**Re: SCC Ref: 2018/0144 and EL 3802– Application by Weybridge Skip Hire to change of the use Units 11 and 12 Wintersells Road, Byfleet, West Byfleet, Surrey KT14 7LF**

Further to my letter of 18 May 2020, and on a re-read of the Officer Report, please find below some further comments on key areas, which I believe the council must take into consideration when making their decision regarding the Wintersells Road site. I have attached a number of graphics and photographs to support my statements

## Vehicle Movements

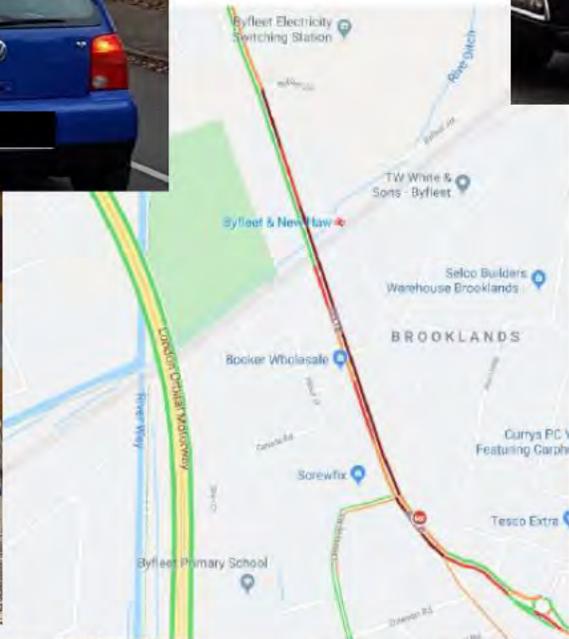
Given the over estimation of capacity in tonnage of Units 11 and 12, the number of vehicle movements should also be re-evaluated for following reasons

- Using the applicant's stated throughput volume and the types of vehicles delivering / removing the waste, the potential throughput could be as much as 220,000 tpa
- To achieve a throughput of 99,500 tpa. only 45 inbound loaded vehicles per day would be needed
- However, given the actual capacity of Units 11 and 12 based on the capacity of Unit 10, only 19 loaded inbound vehicles would be required per day to achieve the throughput of up to 41,000 tpa

NOTE: applicant states that a majority of input will be from their own skips of between 4 and 40 yard capacity. Based on an average skip weight content of 8 ton, the following calculations have been produced.

The vehicle movements given below are for inbound loads only. Thus, the maximum outbound vehicles double the daily vehicle figure - plus there would be probably a further 4 in and 4 out movements of bulk waste removal per day.

# Elevations

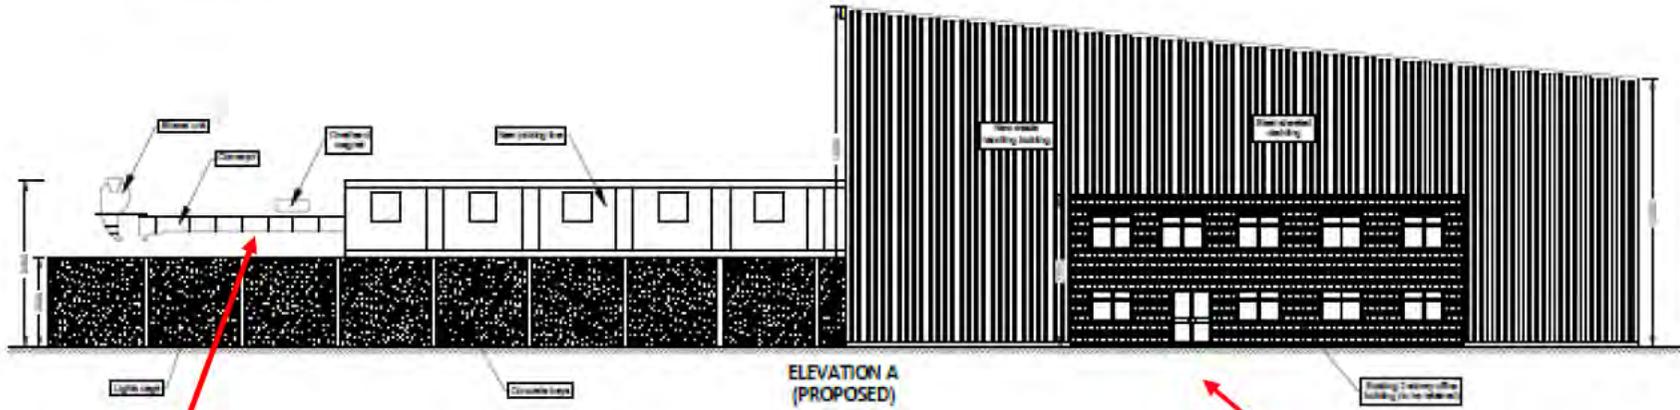
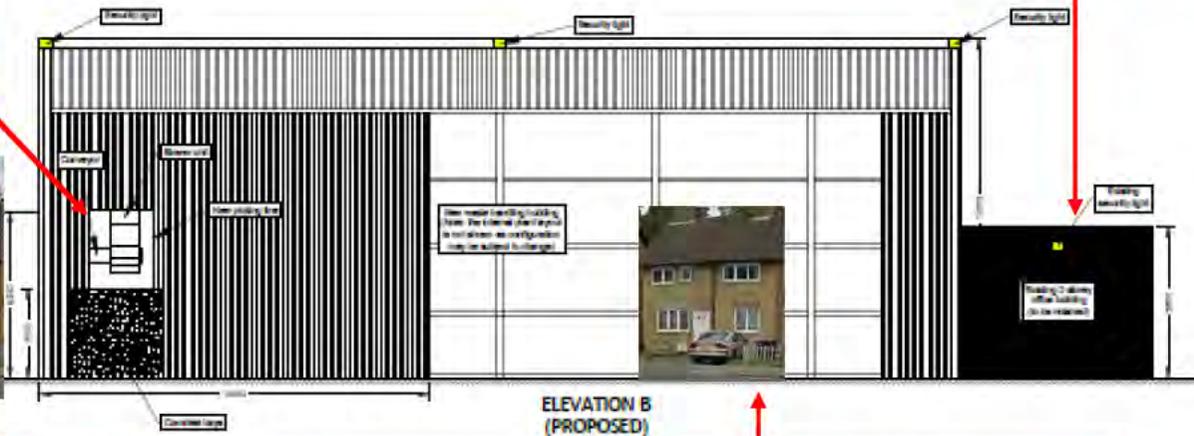
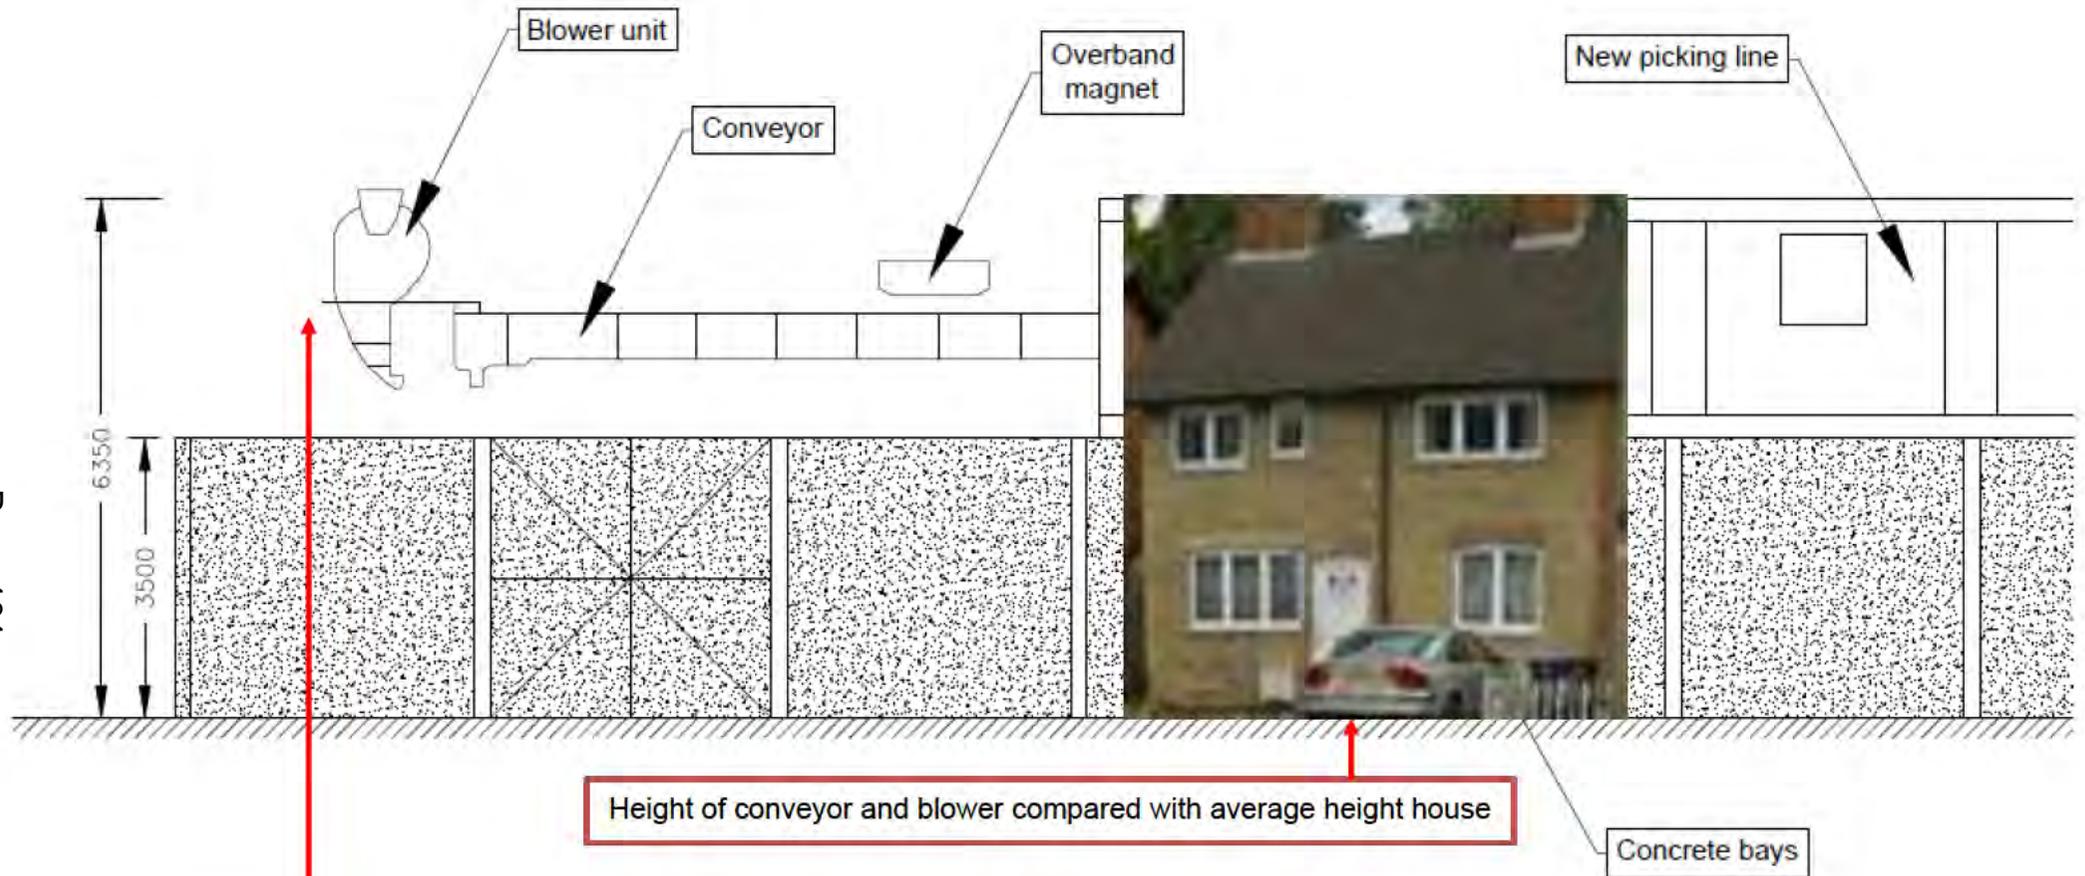
Conveyor – open to the air, sorting and dropping the largest C,D & E waste from height greater than the two storey building

Height of building and conveyor compared with average height house

Height of conveyor and blower compared with average height house

Height of conveyor and blower 6350mm (20.83 ft)  
This is higher than the 2 storey building – see next slide

**Important note:** The existing concrete wall round the boundary of the site is to be retained – part of which will have existing old barbed wire on top. However this wall which will run parallel to the external conveyor (see above) will only be **2500mm high** is not only lower that the conveyor / blower it is also lower that the bins that the waste is dropped into (see site layout plan)

Height of 2 storey building 5800mm (19.02 ft)  
And the height of the new building at 13000mm (42.65 ft) is more than twice the height of the existing building and much higher than any of the other building on this estate.
